Project	<b>IEEE 802.16 Broadband Wireless Access Working Group</b> < <a href="http://ieee802.org/16">http://ieee802.org/16</a> >
Title	<b>Amendment to EAP Security Primitives in 14.2.2.1</b>
Date Submitted	<b>2007-03-0814</b>
Source(s)	Jung-Mo Moon, Jee_Hyeon Na, Mi-Young Yun, and Sangho Lee <a href="mailto:jhna@etri.re.kr">jhna@etri.re.kr</a> ETRI 161 Gajeong-dong, Yuseong-gu Daejeon 305-700 Korea
Re:	Contribution on comments to IEEE 802.16g/D8
Abstract	Re-definition of EAP primitives in 14.2.2.1
Purpose	Adoption
Notice	This document has been prepared to assist IEEE 802.16. It is offered as a basis for discussion and is not binding on the contributing individual(s) or organization(s). The material in this document is subject to change in form and content after further study. The contributor(s) reserve(s) the right to add, amend or withdraw material contained herein.
Release	The contributor grants a free, irrevocable license to the IEEE to incorporate text contained in this contribution, and any modifications thereof, in the creation of an IEEE Standards publication; to copyright in the IEEE's name any IEEE Standards publication even though it may include portions of this contribut

Figure 473 – EAP based Authentication Procedure

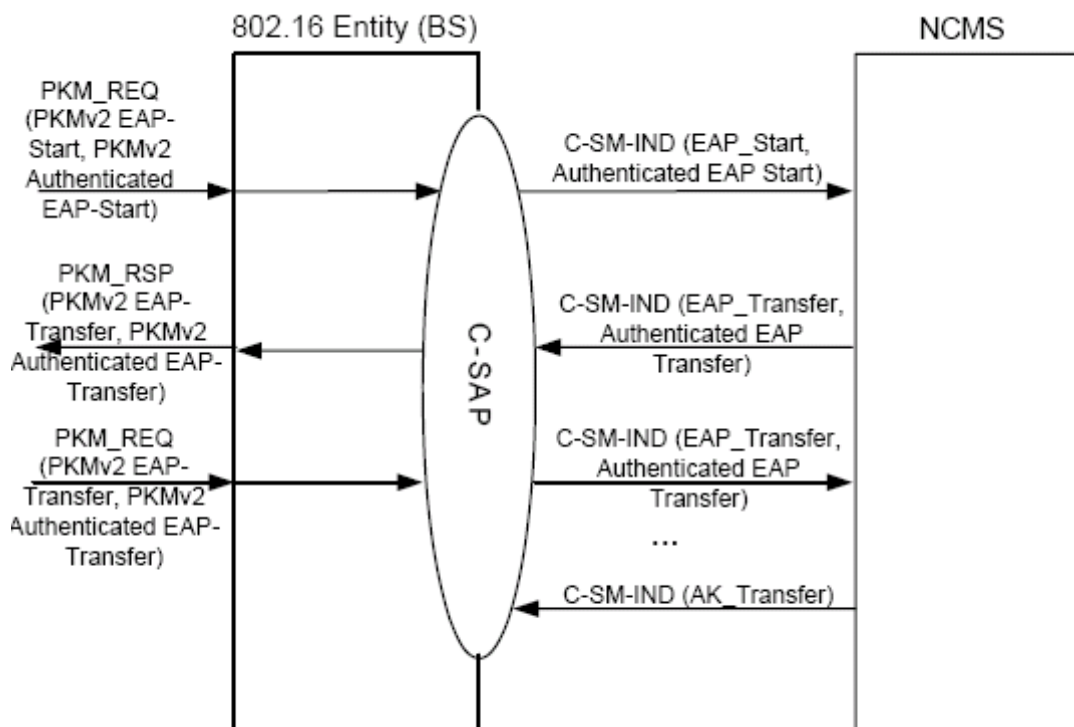
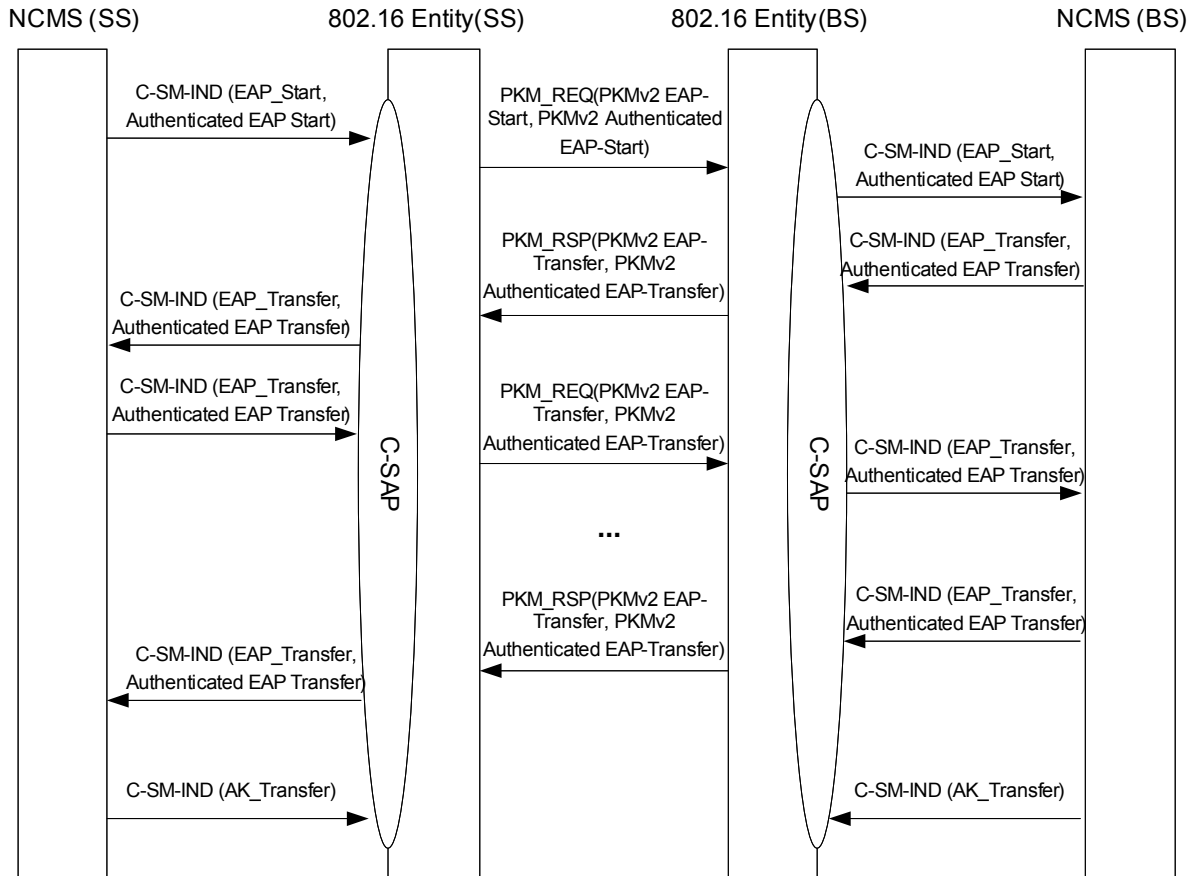
1. Modification of figure 473 to illustrate EAP-based security primitives on SS side.
2. Modification of each subsection to clarify and describe on each side (SS and BS side)

Figure 473 shows EAP-based authentication procedures between an BS-802.16 entity and an NCMS on SS and BS sides and an AAA Services entity in NCMS as follows:
